C2PC letter

Subject: FCC Class II Permission change for FCC ID: 2AO23-TWS09

This is to request a Class II permission change to our product name: TWS Active Noise Canceling Earbuds; Model: TWS09 (FCC ID: 2AO23-TWS09), the device is identical to the previously certified except for the Changes as below for details;

PCB Difference

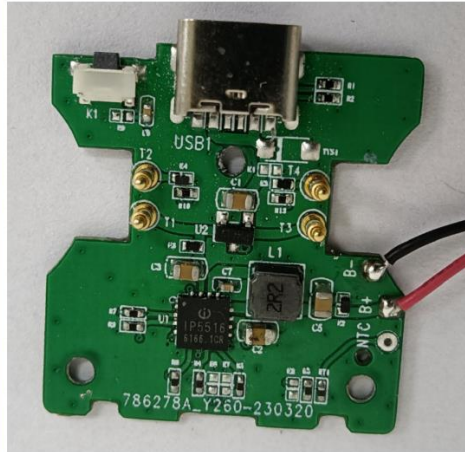
- 1) Components modification on charging case PCB: keypad parts, charging pins, Type-C port components and inductors; partial ESD components removed.
- 2) Earbud PCB: Antenna pogo pins and contact pogo pins replacement.
